APPENDIX 2.1

Fehr & Peers Responses to Comments Memoranda

Date: January 12, 2016
To: Yen Chen, City of Santa Clara, Planning Department
From: Ann Bowers, PE, PTOE and Andrew McFadden – Fehr & Peers
Subject: **Mission Town Center Draft EIR – Caltrans Response to Comments**

Date: January 12, 2016
To: Yen Chen, City of Santa Clara, Planning Department
From: Ann Bowers, PE, PTOE and Andrew McFadden – Fehr & Peers
Subject: **Mission Town Center Draft EIR – VTA Response to Comments**

Figure 3. Archaeological features near the Mission Town Center Project Site highlighting features specifically discussed in the text.

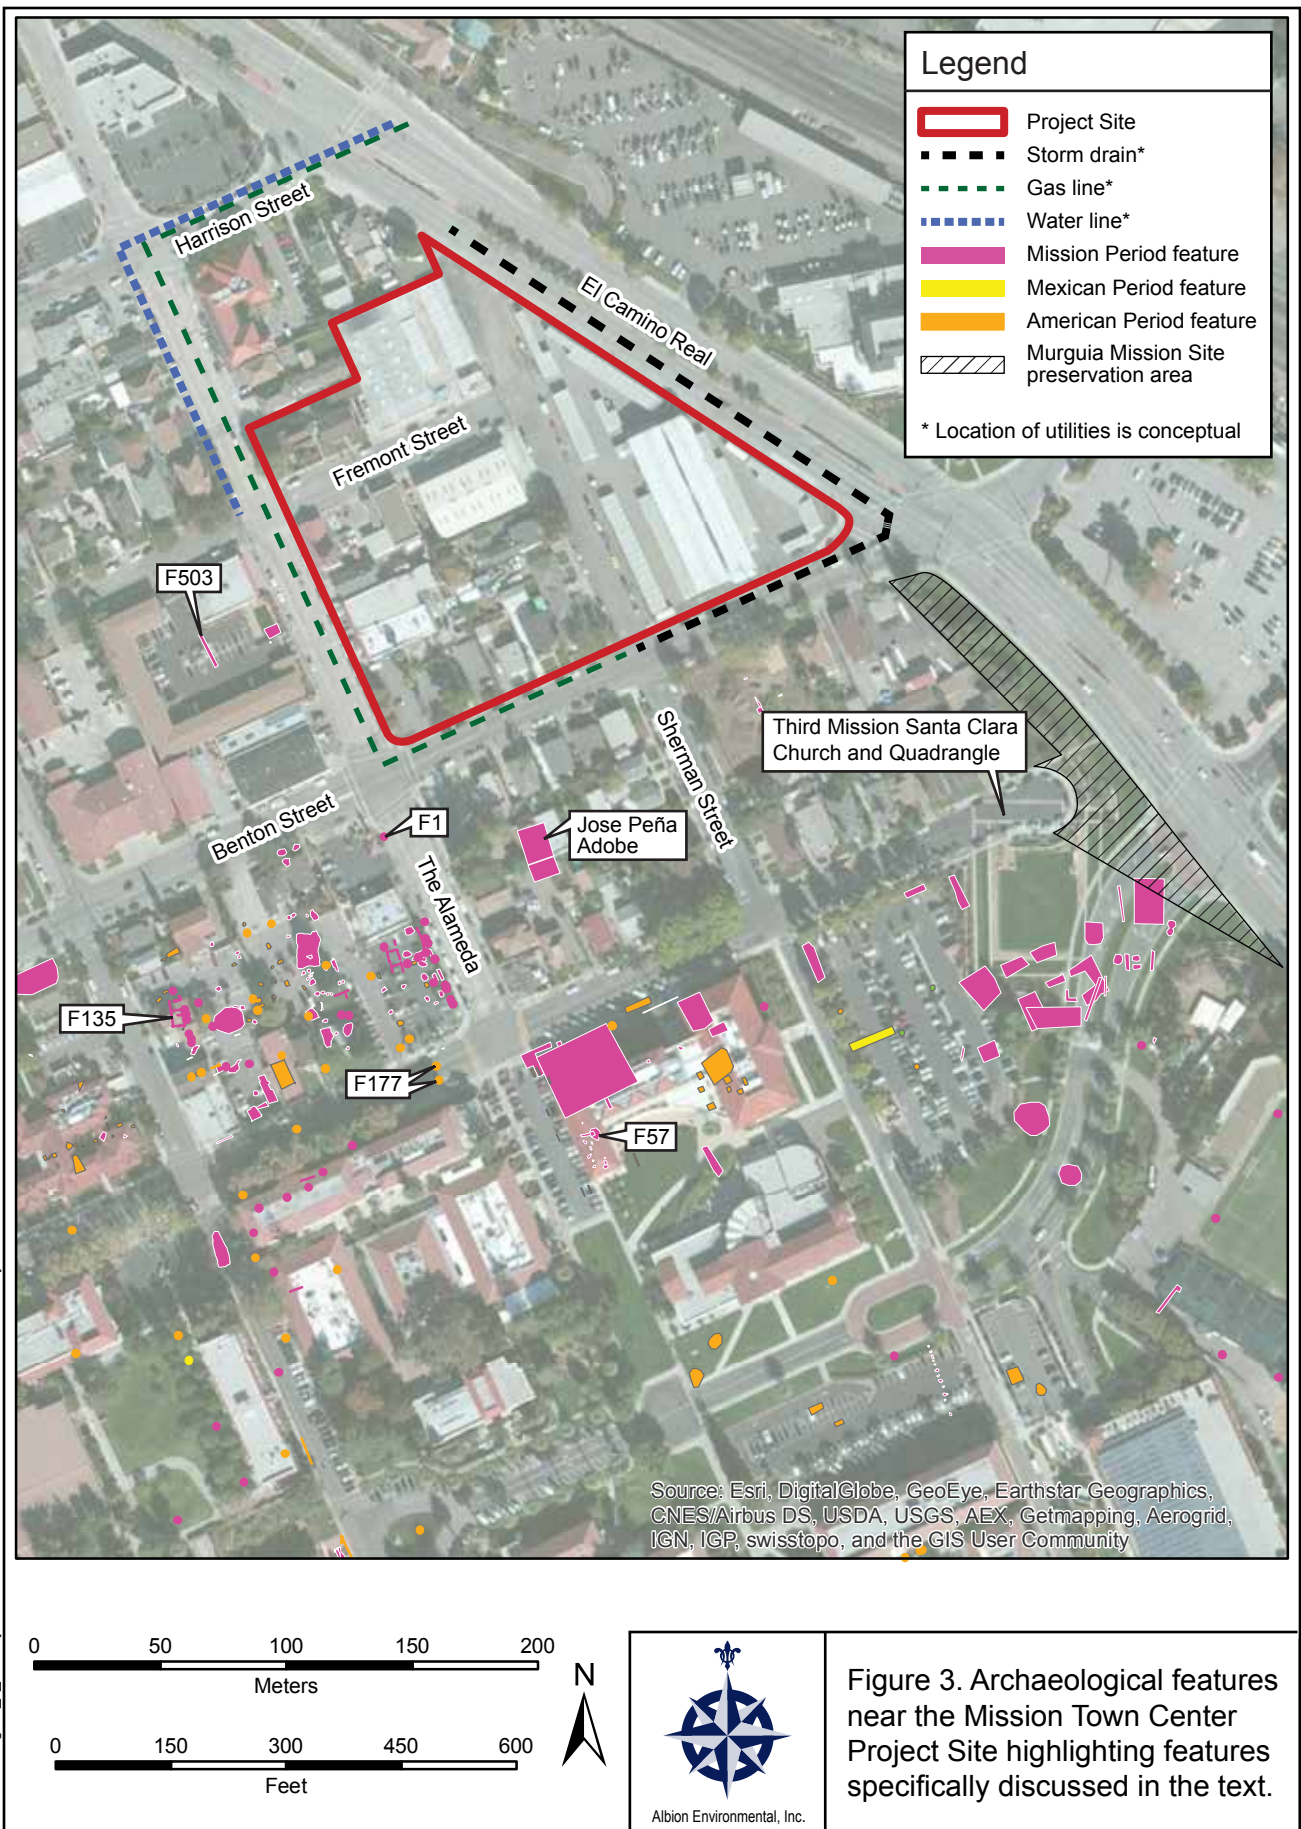
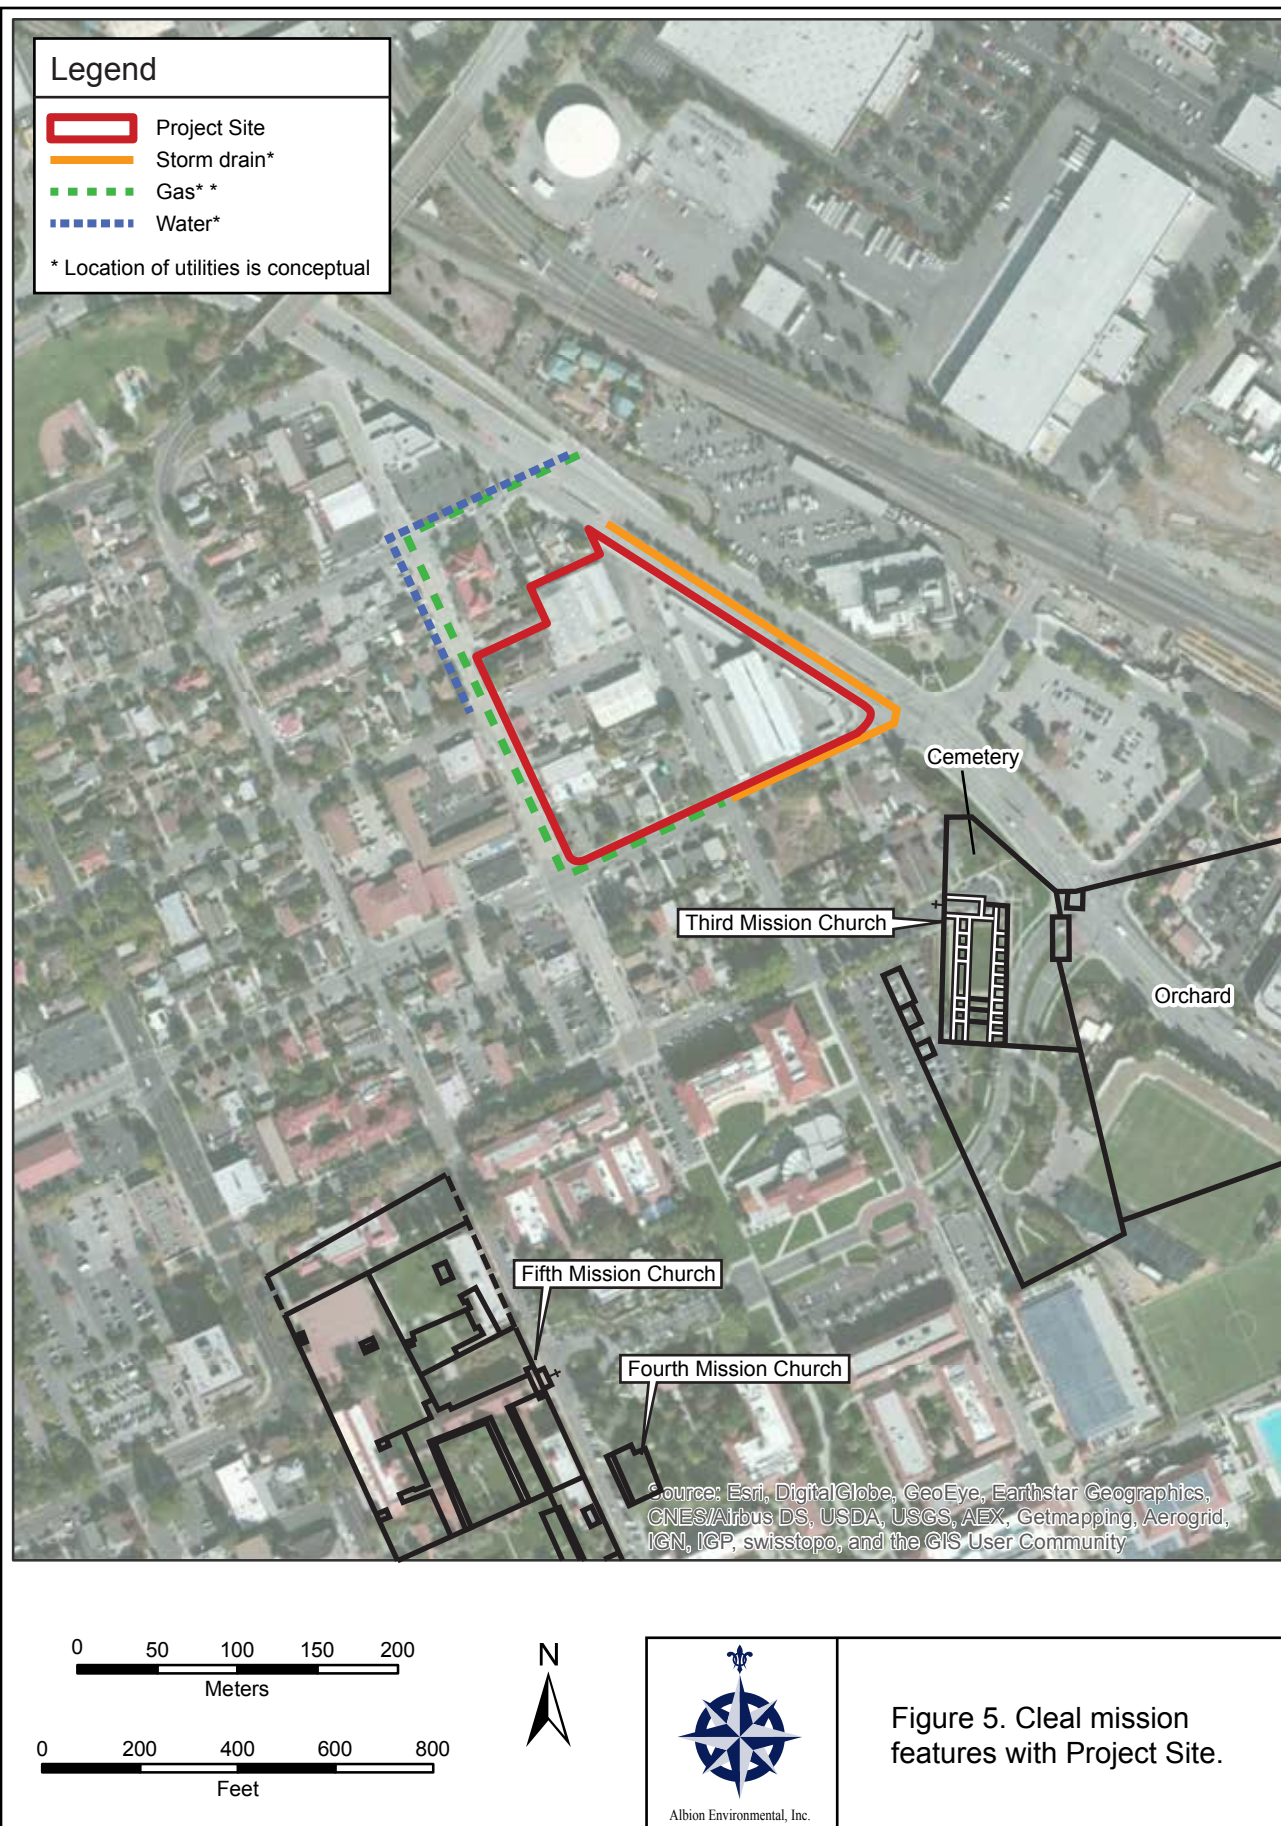
4.2.2.2 Archaeological Resources and Human Remains in the Project Vicinity <i>Spanish Colonial Era</i>	First paragraph, first sentence: "at three distinct locations." Correction: There were four distinct locations for the mission churches. Please correct to read "at four distinct locations."	Changed as requested to "at four distinct locations."
	First paragraph, second sentence: "Three of these churches in two separate locations exist within the modern SCU campus." Correction: Only two of these currently exist within the SCU campus. The other sites consist of one site north of 101, one north of Martin Street and one (the Third Mission site) at the end of the Franklin Street cul-de-sac. Please correct to read "Two of these churches in two locations exist within the modern SCU campus."	The change was not made because the Third Mission site is partially on SCU campus. Please refer to Figure 5 of the Treatment Plan that shows John Cleal’s placement of the Third Mission.

11at three distinct locations.at four distinct locations.
19	To date there appears to be one large neophyte living complex at Mission Santa Clara, despite	“To date there appears to be one large neophyte residential complex at Mission Santa Clara with numerous components ,....
30	The Late Mexican/American Period Landscape	The Late Mexican/ Early American Period Landscape
32	The presence of Feature 16 indicates at least a partial sewer system within this American Period neighborhood (Baxter et al. 2011:204).	The presence of Feature 16 indicates at least a partial sewer system within this Early American Period neighborhood (Baxter et al. 2011:204).
122	This monitoring should occur after demolition but before construction grading in specific areas within the Project, determined to be the most sensitive based on background research.	This monitoring should occur after demolition but before construction grading in specific areas within the Project, determined to have a greater likelihood of in-situ preservation and cultural integrity based on background research.
